Addendum # 01

**To the Contract Specifications and Drawings for:
Saddle Hills County
Bonanza Distribution Pumps Upgrading**

File: 5201-008-00

DESIGNED I.A.K., S.M.	JOB 5201-008-00
DRAWN J.M.M.	SCALE 1:75
DATE JANUARY 2025	DRAWING P2.1 ADD01

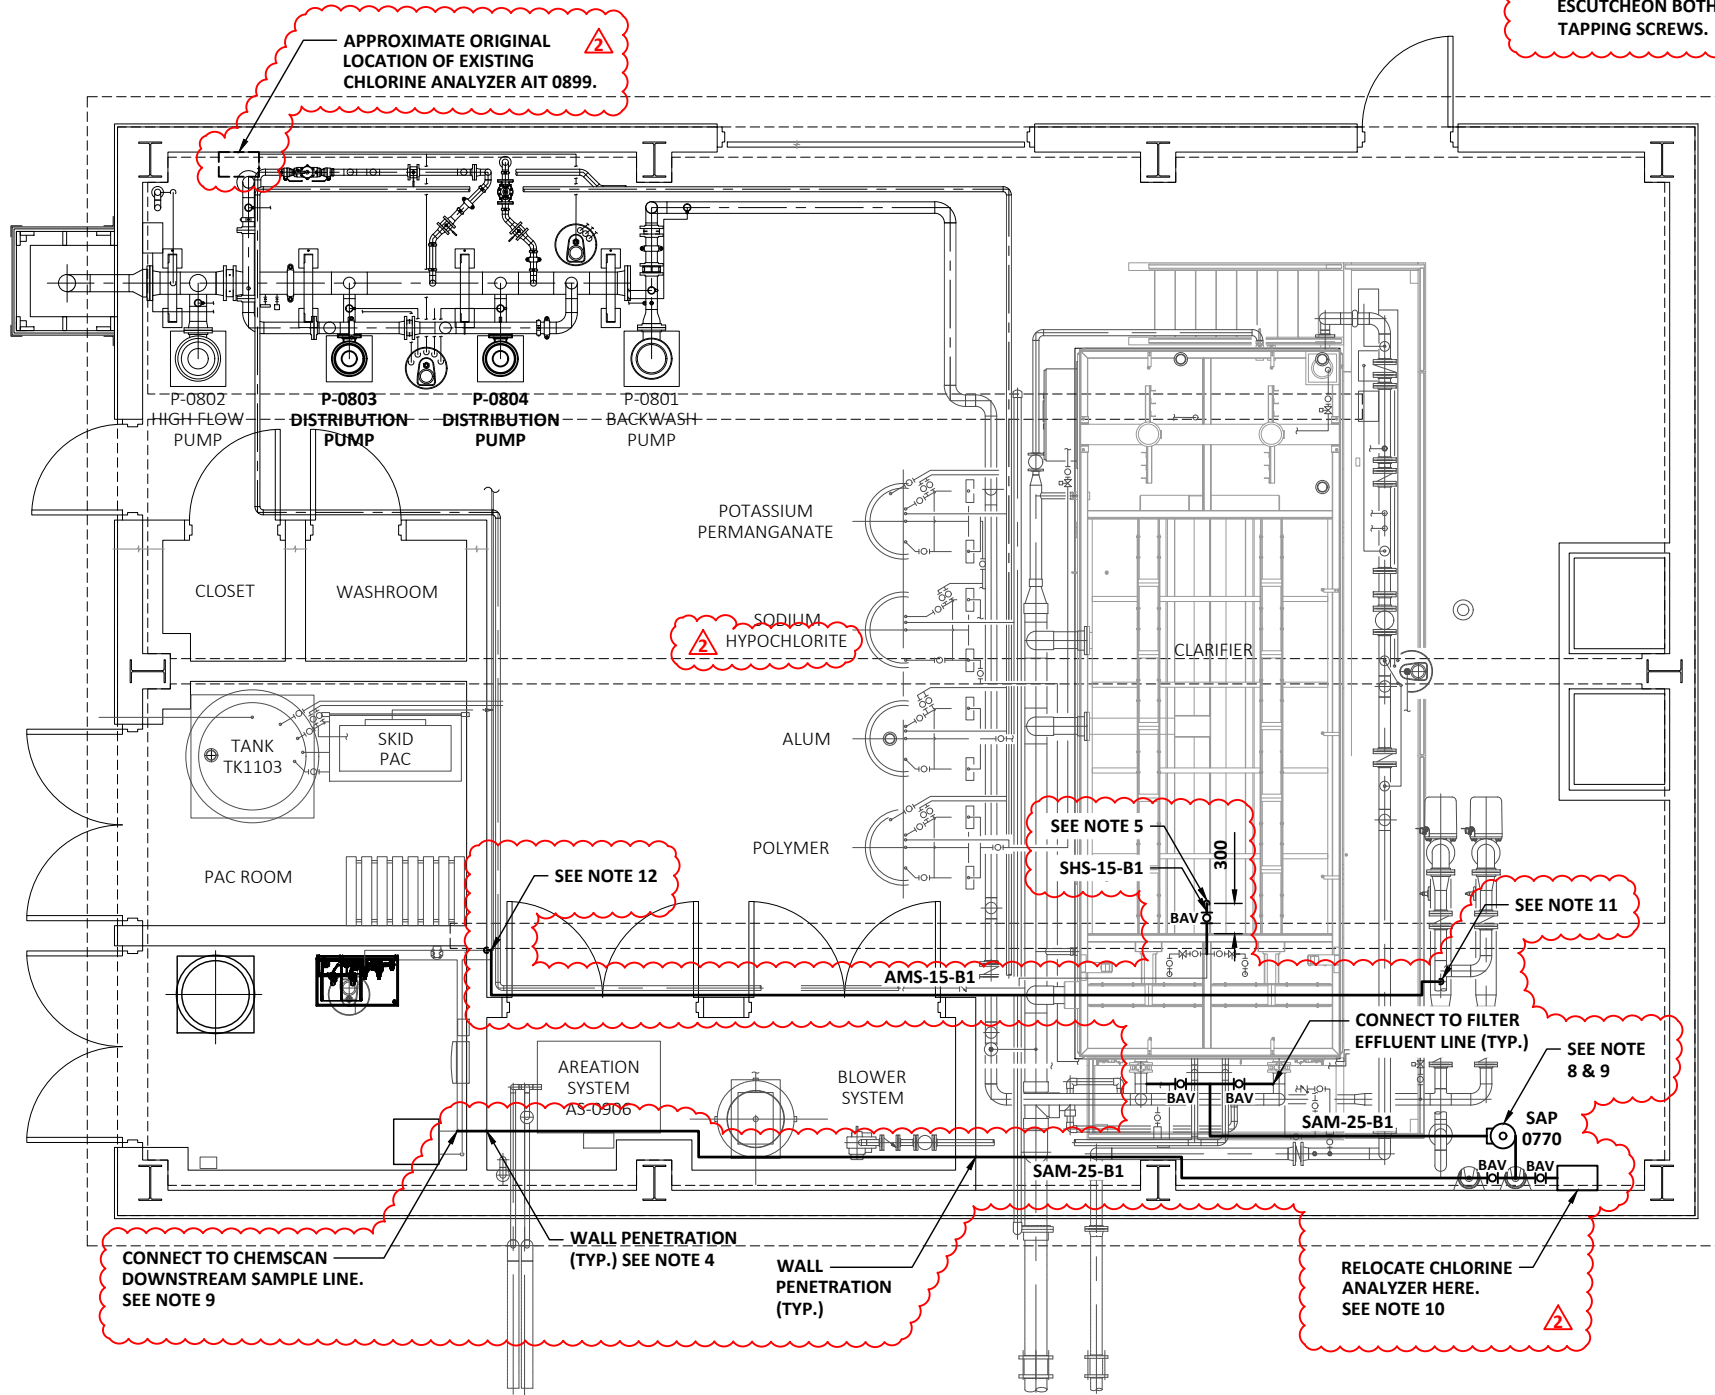
10. RELOCATE CHLORINE ANALYZER ON NORTH EAST AREA OF THE WTP. PROVIDE ADEQUATE SUPPORT SUCH THAT ANALYZER IS 1200mm ABOVE FLOOR.
11. DISCONNECT AMMONIA SOLUTION INJECTION POINT AND CONNECT TO EXISTING INJECTION POINT DOWNSTREAM OF UV DISINFECTION UNITS.
12. RELOCATE AMMONIA SOLUTION LINE AS REQUIRED. UTILIZE EXISTING CHEMICAL LINES. FLUSH LINES PRIOR TO COMMISSIONING.
13. WALL PENETRATION TO SUIT PIPING. FILL VOID WITH FIRE STOPPING. PROVIDE ALUMINUM SHEET METAL ESCUTCHEON BOTH SIDES. SECURE WITH STAINLESS STEEL TAPPING SCREWS.

5. RELOCATE SODIUM HYPOCHLORITE INJECTION LINE TO CENTER OF CLARIFIER. LINE SIZE AND MATERIAL TO MATCH EXISTING. UTILIZE EXISTING PIPING THAT HAS BEEN RUN TO THE FILTERS. RECONNECT THIS PIPING TO CHEMICAL FEED SYSTEM.

6. DISCONNECT AND DISPOSE OF EXISTING SODIUM HYPOCHLORITE INJECTION LINES TO FILTER AND POST UV. CONFIRM EXTENT OF REMOVALS WITH ENGINEER.
7. CONTRACTOR TO INSTALL SAP 0770 IN AREA APPROVED BY OWNER. LOCATION TO BE EASILY ACCESSIBLE FOR MAINTENANCE AND REMOVAL OF PUMP. INSTALL IN ACCORDANCE WITH MANUFACTURER'S RECOMMENDATION. INCLUDE ALL SUPPORTS REQUIRED.

8. CONTRACTOR TO RUN FEED SAMPLE LINE NEATLY TO NOT OBSTRUCT PASSAGE WAYS OR WORK AREAS. SUPPORT AS REQUIRED. CONNECT TO FILTER 1 AND FILTER 2 TREATED WATER LINES AT LOCATIONS APPROVED BY ENGINEER. CONNECTION POINT TO BE AT SIDE OF PIPE.

9. CONTRACTOR TO RUN SUPPLY SAMPLE LINES NEATLY TO NOT OBSTRUCT PASSAGE WAYS OR WORK AREAS. SUPPORT AS REQUIRED. CONNECT TO CHEMSCAN DOWNSTREAM LINE. CONNECT TO FREE CHLORINE ANALYZER FEED LINE. REMOVE AND DISPOSE OF EXISTING SAMPLE LINES. RUN SAMPLE LINES TO AVOID HIGH POINTS.

DESIGNED I.A.K., S.M.	JOB 5201-008-00
DRAWN J.M.M.	SCALE 1:75
DATE JANUARY 2025	DRAWING P2.10 ADD01

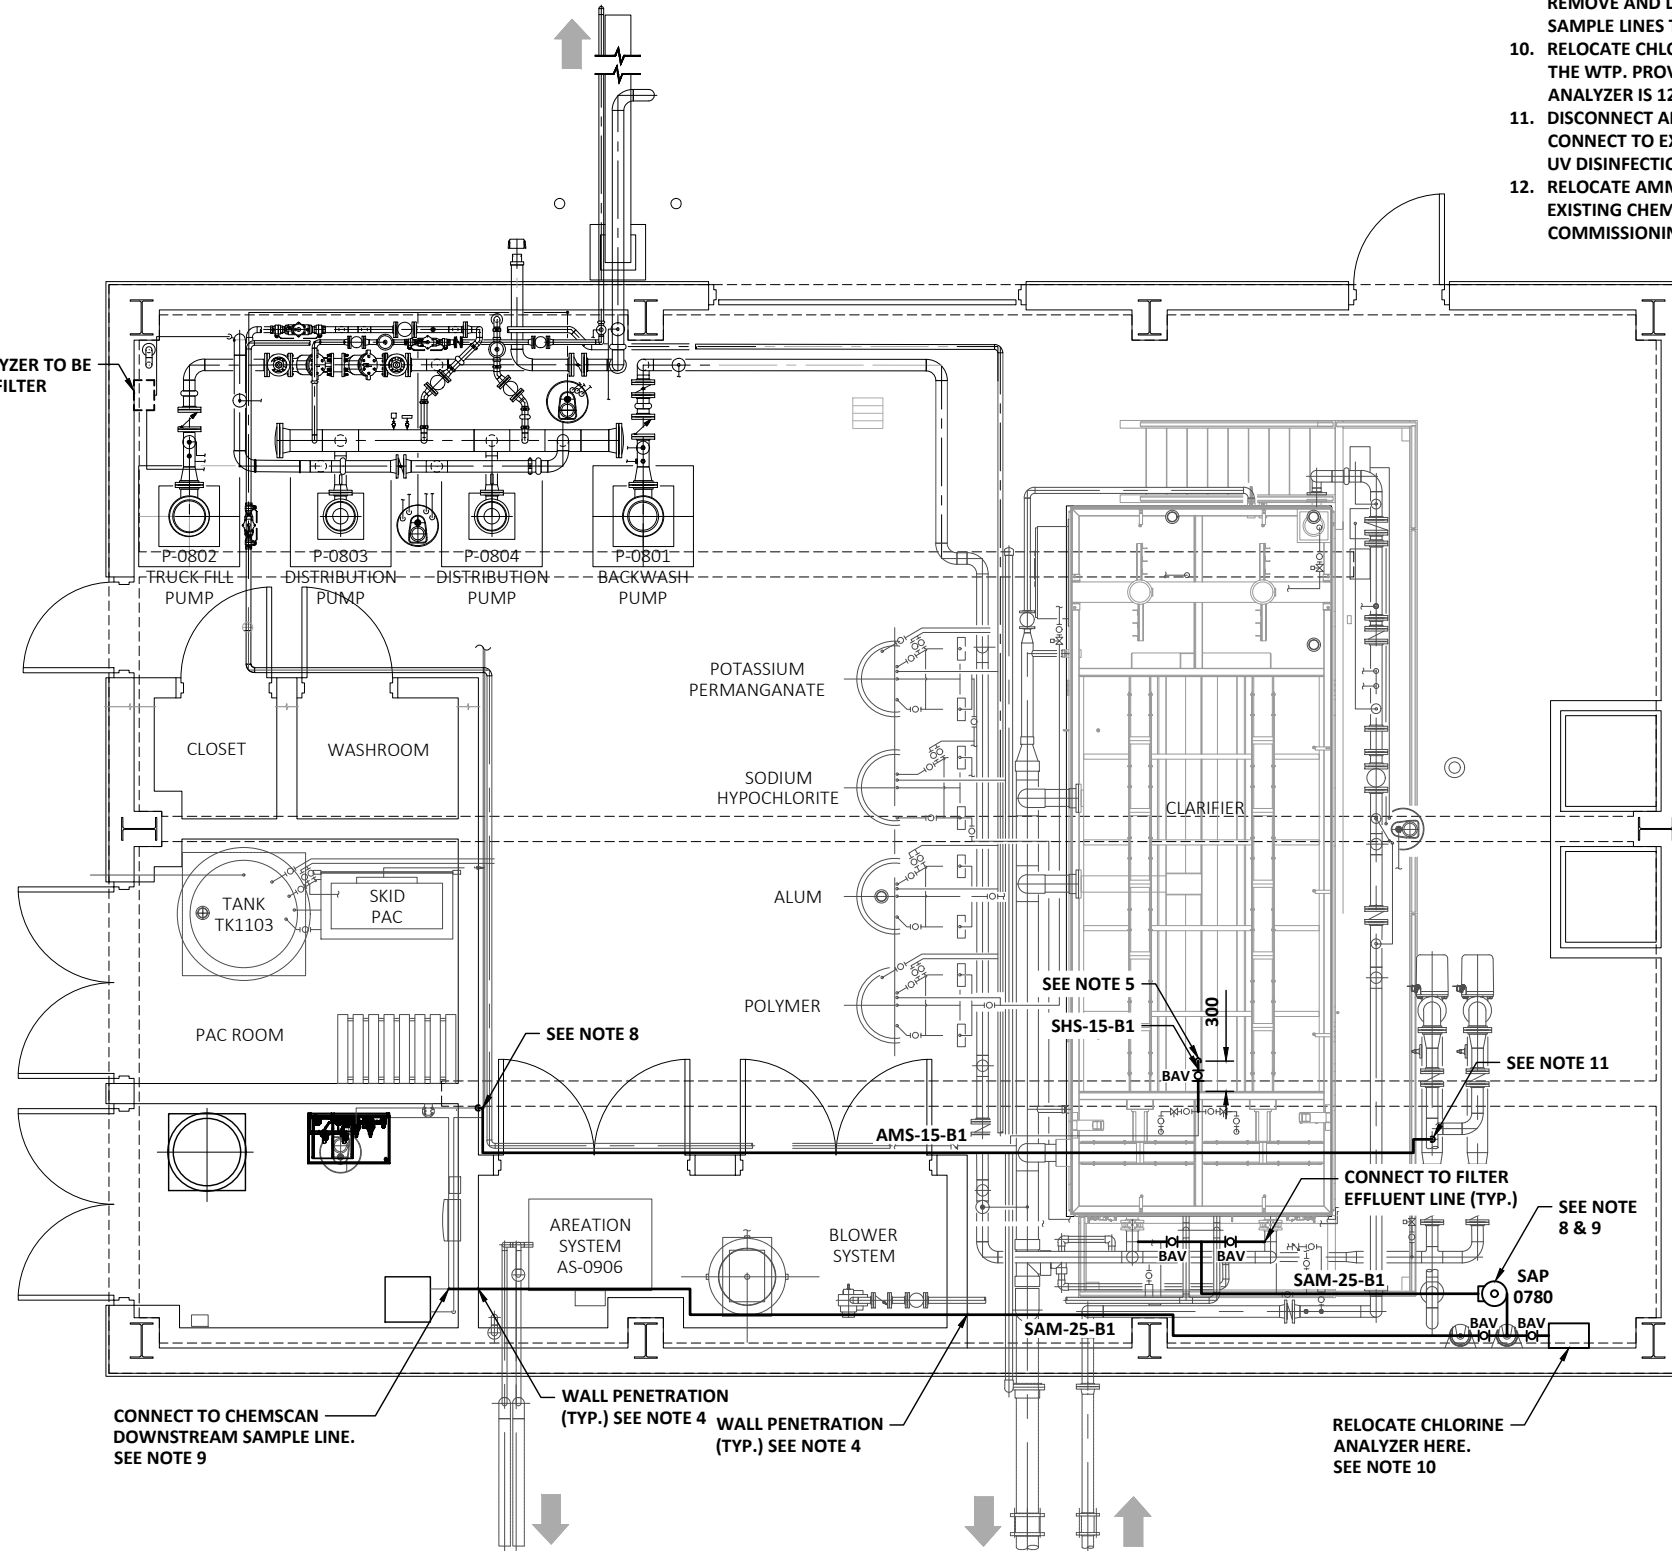
CHLORINE ANALYZER TO BE RELOCATED TO FILTER EFFLUENT AREA.

9. CONTRACTOR TO RUN SUPPLY SAMPLE LINES NEATLY TO NOT OBSTRUCT PASSAGE WAYS OR WORK AREAS. SUPPORT AS REQUIRED. CONNECT TO CHEMSCAN DOWNSTREAM LINE. CONNECT TO FREE CHLORINE ANALYZER FEED LINE. REMOVE AND DISPOSE OF EXISTING SAMPLE LINES. RUN SAMPLE LINES TO AVOID HIGH POINTS.
10. RELOCATE CHLORINE ANALYZER ON NORTH EAST AREA OF THE WTP. PROVIDE ADEQUATE SUPPORT SUCH THAT ANALYZER IS 1200mm ABOVE FLOOR.
11. DISCONNECT AMMONIA SOLUTION INJECTION POINT AND CONNECT TO EXISTING INJECTION POINT DOWNSTREAM OF UV DISINFECTION UNITS.
12. RELOCATE AMMONIA SOLUTION LINE AS REQUIRED. UTILIZE EXISTING CHEMICAL LINES. FLUSH LINES PRIOR TO COMMISSIONING.

5. RELOCATE SODIUM HYPOCHLORITE INJECTION LINE TO CENTER OF CLARIFIER. LINE SIZE AND MATERIAL TO MATCH EXISTING. UTILIZE EXISTING PIPING THAT HAS BEEN RUN TO THE FILTERS. RECONNECT THIS PIPING TO CHEMICAL FEED SYSTEM.

6. DISCONNECT AND DISPOSE OF EXISTING SODIUM HYPOCHLORITE INJECTION LINES TO FILTER AND POST UV. CONFIRM EXTENT OF REMOVALS WITH ENGINEER.
7. CONTRACTOR TO INSTALL SAP 0770 IN AREA APPROVED BY OWNER. LOCATION TO BE EASILY ACCESSIBLE FOR MAINTENANCE AND REMOVAL OF PUMP. INSTALL IN ACCORDANCE WITH MANUFACTURER'S RECOMMENDATION. INCLUDE ALL SUPPORTS REQUIRED.

8. CONTRACTOR TO RUN FEED SAMPLE LINE NEATLY TO NOT OBSTRUCT PASSAGE WAYS OR WORK AREAS. SUPPORT AS REQUIRED. CONNECT TO FILTER 1 AND FILTER 2 TREATED WATER LINES AT LOCATIONS APPROVED BY ENGINEER. CONNECTION POINT TO BE AT SIDE OF PIPE.

DESIGNED	A.M., P.P.G.	JOB	5201-008-00
DRAWN	A.M.	SCALE	NTS
DATE	JANUARY 2025	DRAWING	E1.2 ADD01

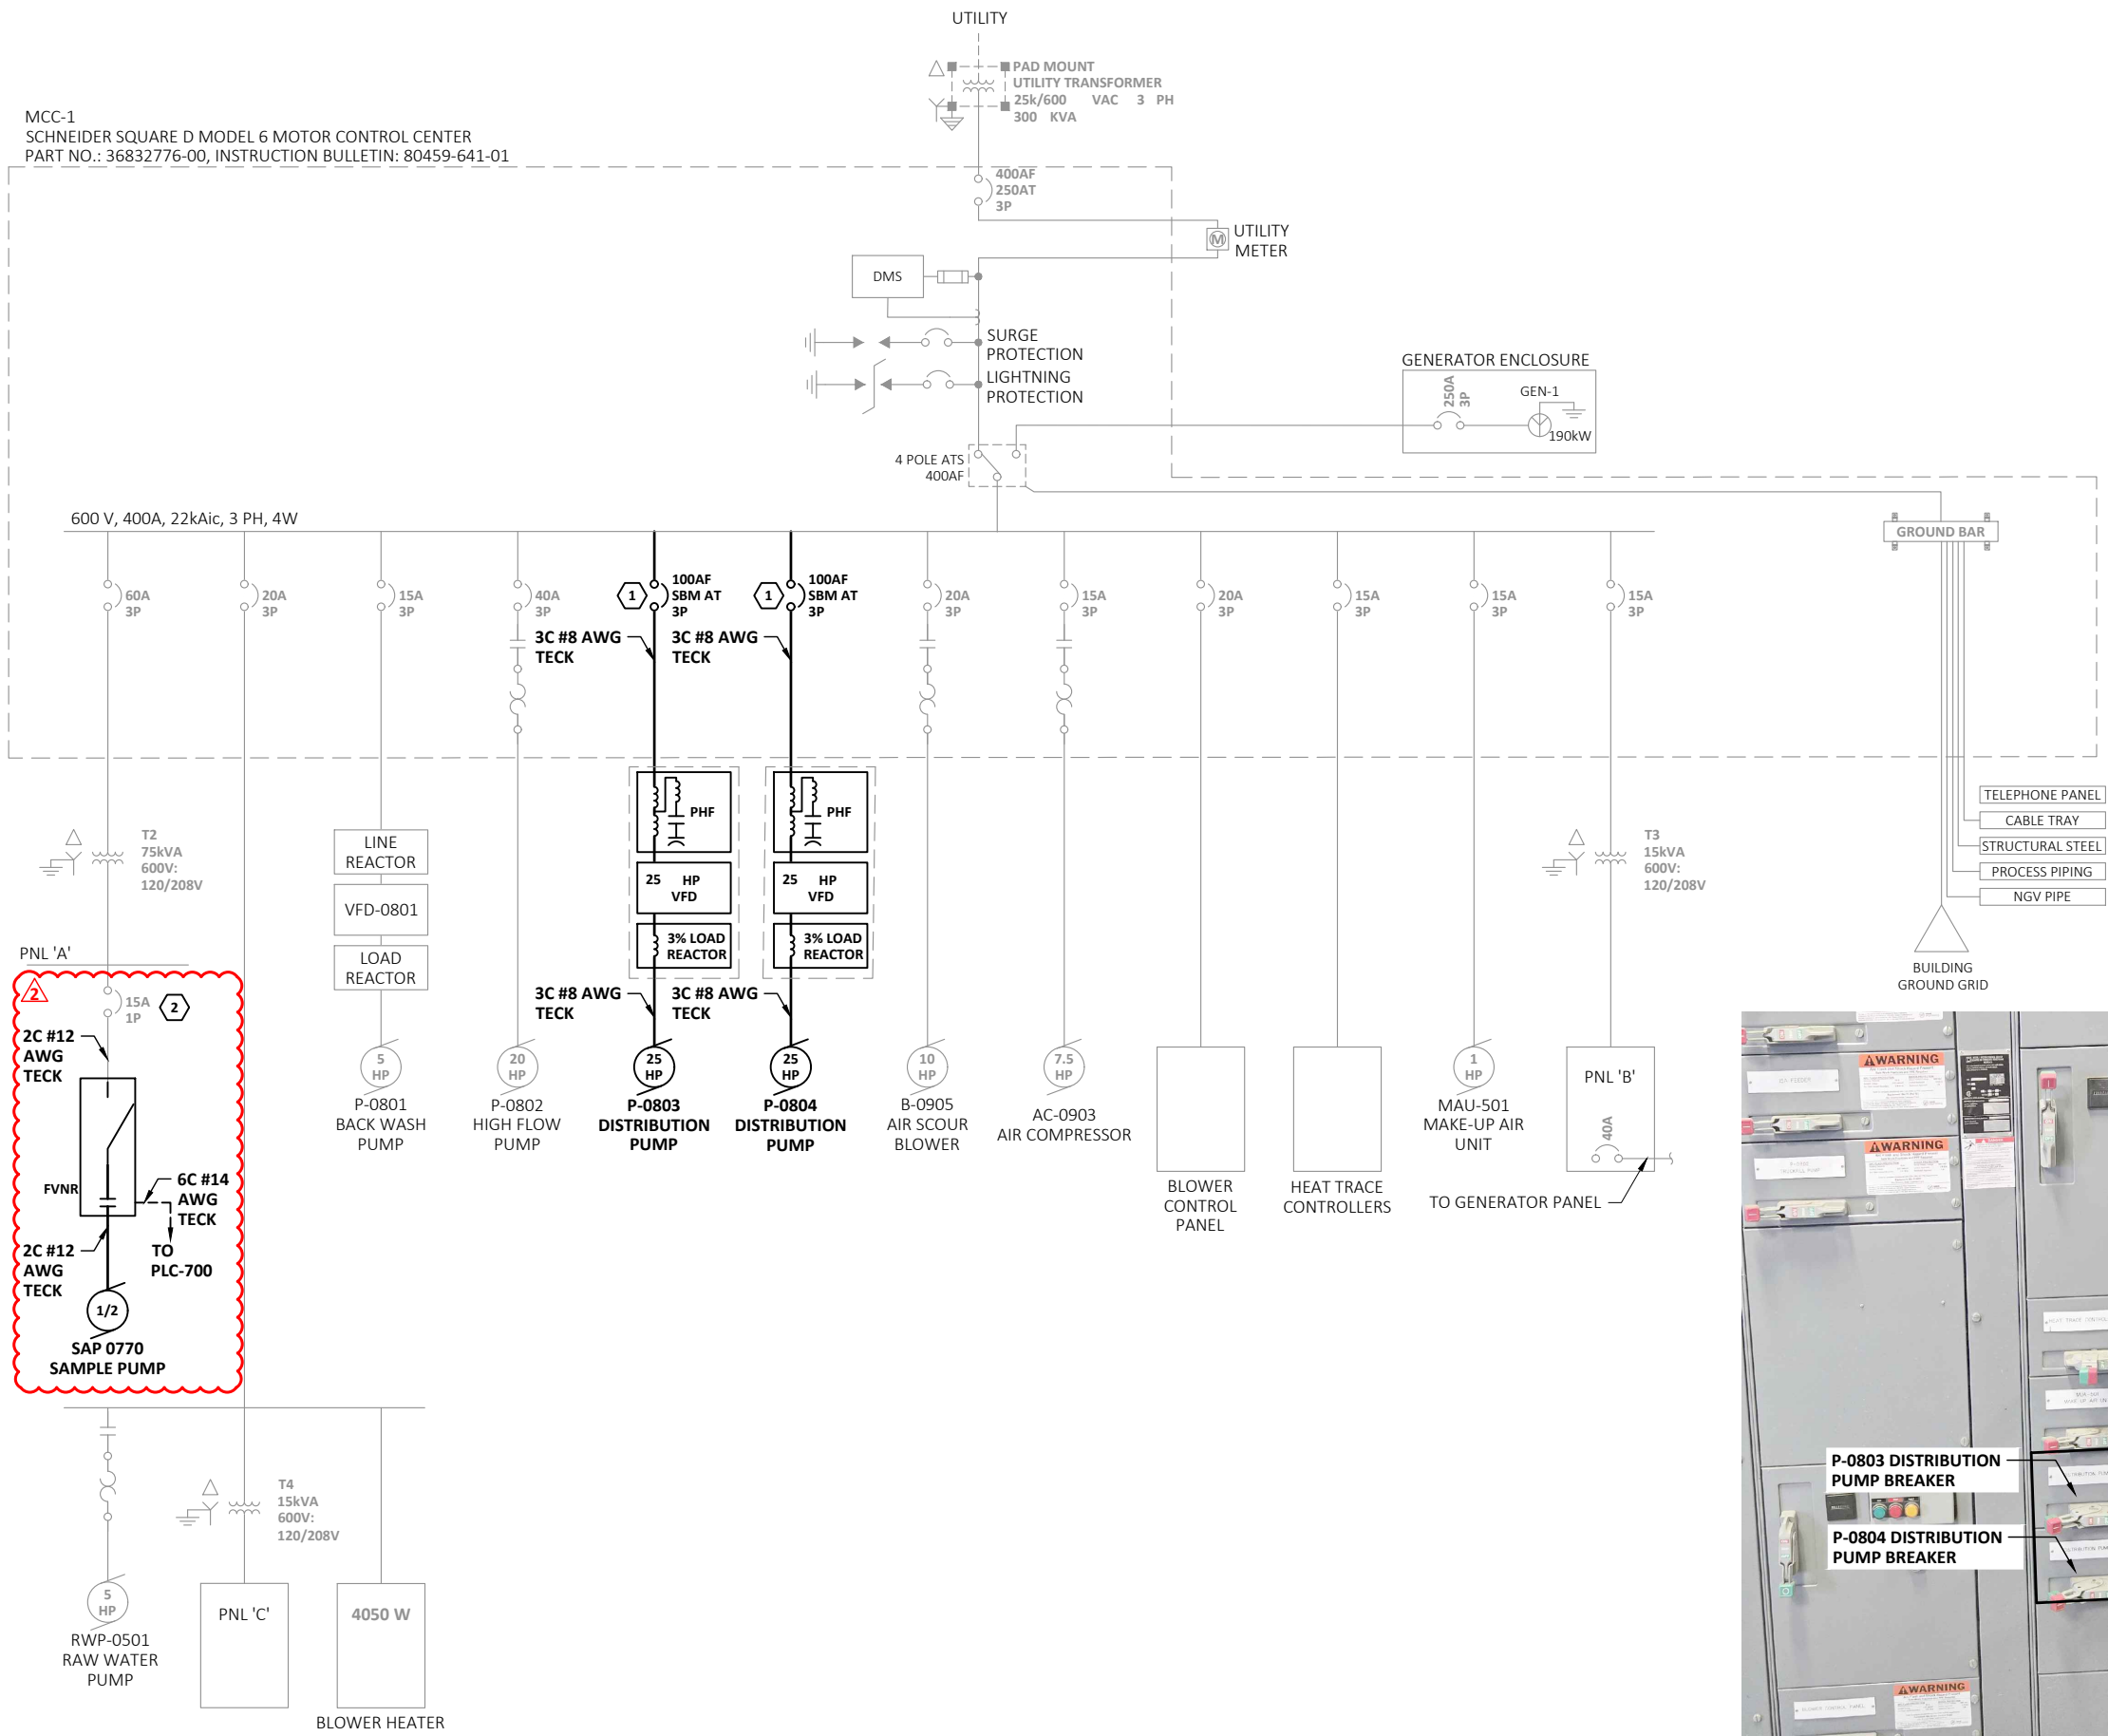
- KEY NOTES:
- REPLACE THE EXISTING BREAKER BUCKET ALONG WITH DOOR AND LABEL AS REQUIRED. NEW BREAKERS SHALL BE LOCKABLE. FOR DETAILS ON EXISTING MCC PLEASE REFER TO SCHNEIDER SQUARE D MODEL 6 MOTOR CONTROL CENTER PART NO.: 36832776-00, INSTRUCTION BULLETIN: 80459-641-01
 - UTILIZE EXISTING SPARE BREAKER IN PANEL A.
